PZ&B Staff Combination Memorandum: Architectural Commission (ARCOM) and Town Council

SUBJECT: ARC-24-0033 (ZON-24-0021) 1356 N OCEAN BLVD

MEETING: AUGUST 28, 2024
SEPTEMBER 11, 2024

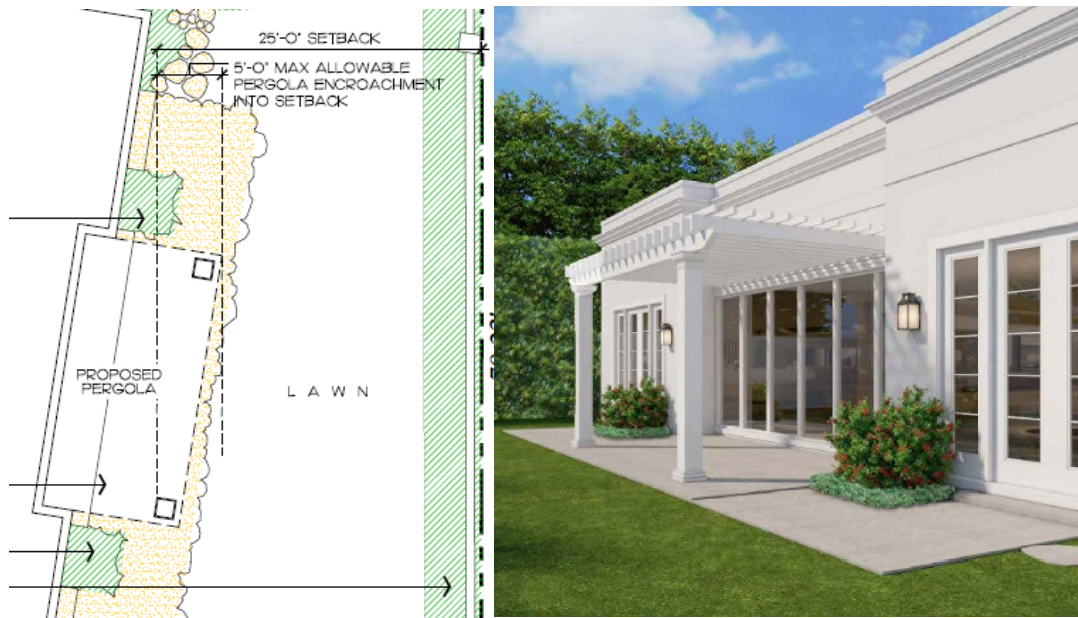
The proposed pergola necessitates a variance due to its height exceeding the maximum allowed. The structure is to be installed on the east side of the house, positioned above existing windows that are over 9'-0" in height, within the required side street setback. Installing the pergola at a height of 9'-0" or lower would obstruct both the windows and the view.

Furthermore, the applicant intends to modify more than 50% of the existing landscape open space. Per zoning code, any alteration of 50% or more of the existing landscape area requires that the landscape open space calculations comply with current requirements. Although the applicant proposes an improvement from existing conditions, with 43.2% open space (an increase from the existing 42.9%), a variance is still required as it does not meet the minimum 45% requirement.
